QUICKBASE CHANGE PROPOSAL: *X296 RR FLOOR*

Customer	Project Name	Customer EC	MRE EC	Date Proposal	Made By
<i>Daimler</i>	<i>X296 EVA-II</i>	<i>TBD</i>	<i>EC 714</i>	<i>25-Feb-2022</i>	<i>A. Porbadnik</i>
Part Numbers Affected	<i>A2966115500/5600</i>		Part Names	<i>LONGITUDINAL MEMBER FRT UPR LH / RH</i>

Customer	Project Name	Customer EC	MRE EC	Date Proposal	Made By
<i>Daimler</i>	<i>X296 EVA-II</i>	<i>TBD</i>	<i>EC 714</i>	<i>25-Feb-2022</i>	<i>A. Porbadnik</i>
Part Numbers Affected	<i>A2966182300</i>		Part Names	<i>FLOOR UNDER REAR SEAT</i>

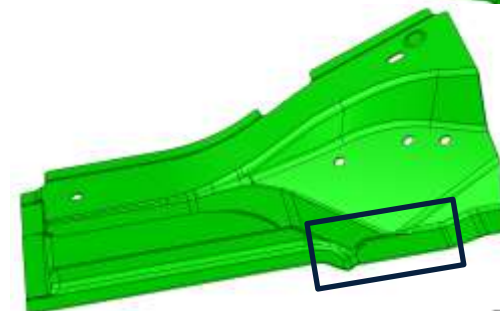
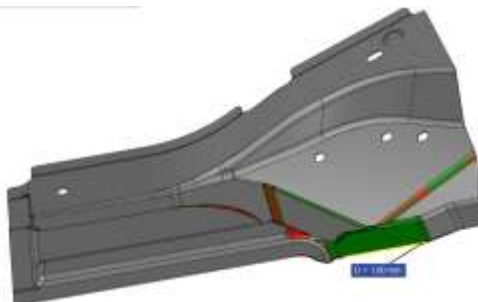
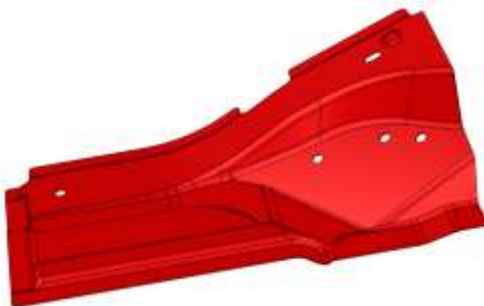
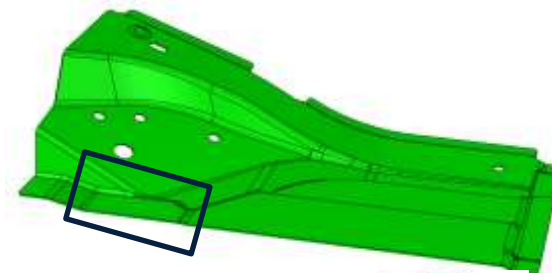
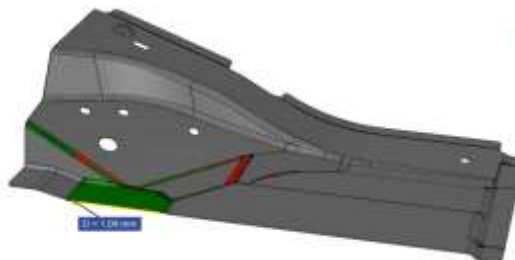
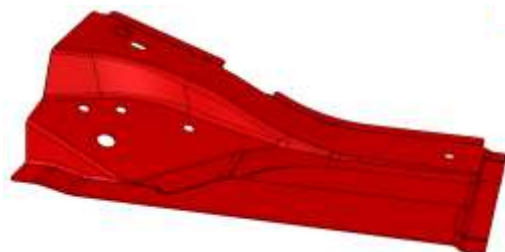
Current Status, Problem Description	A2966115500 0012.03 ZGS: 0004 A2966115600 0012.03 ZGS: 0004 Correction in CAD to improve reducing the gaps in seat attachment area	New Status, Solution Description	STUDY FILES A2966115500 0013.04 A2966115600 0013.04 Collision with SPR, surface of press parts moved by 1mm in +Z direction
---	---	--	---

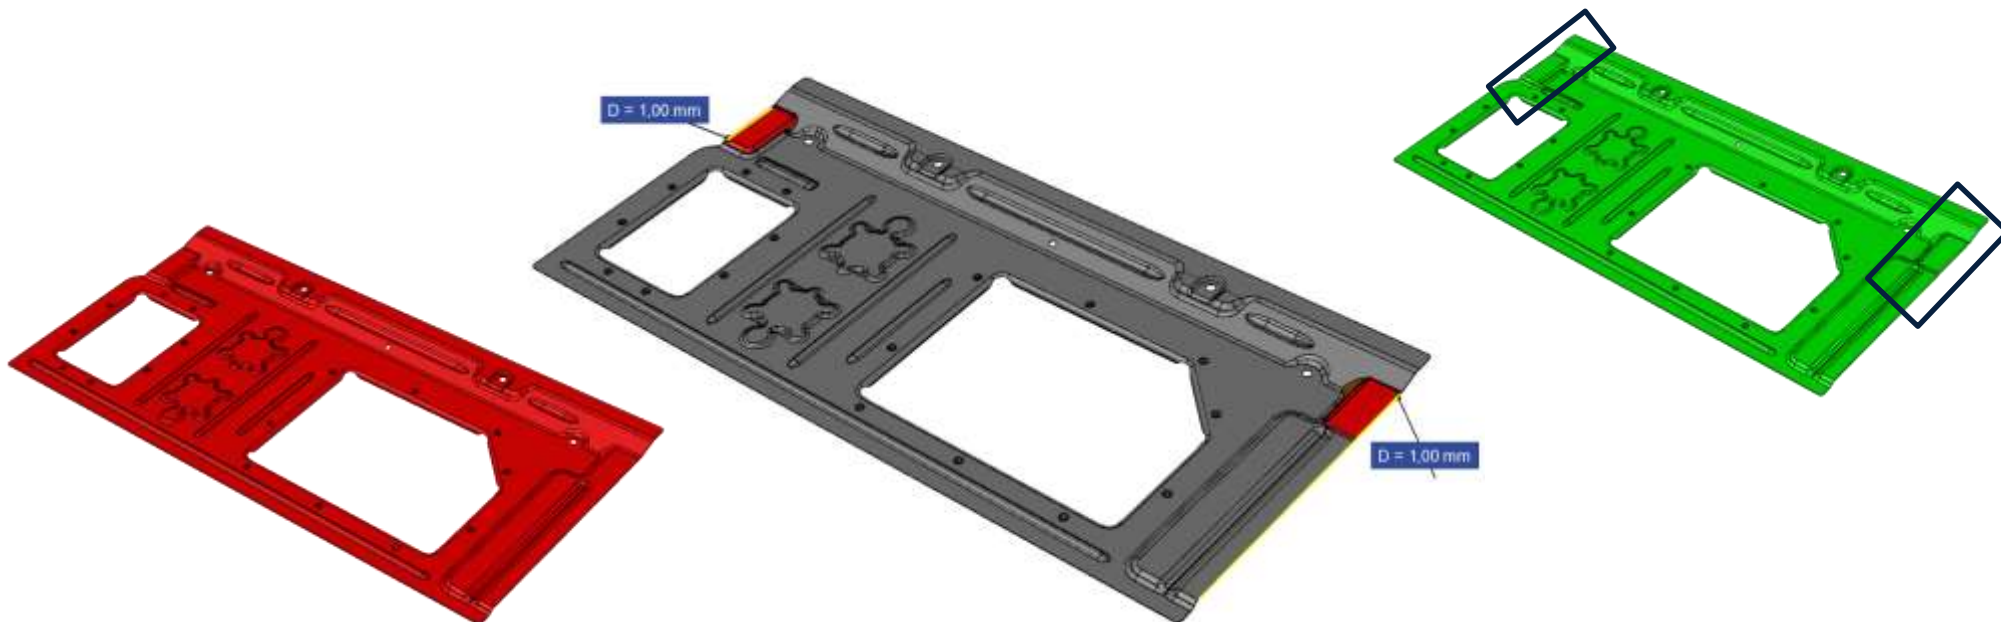
A2966182300 0012.03 ZGS: 0005
Correction in CAD to improve reducing the
gaps in seat attachment area

STUDY FILES
A2966182300 0013.03
Collision with SPR, surface of press parts
moved by 1mm in +Z direction
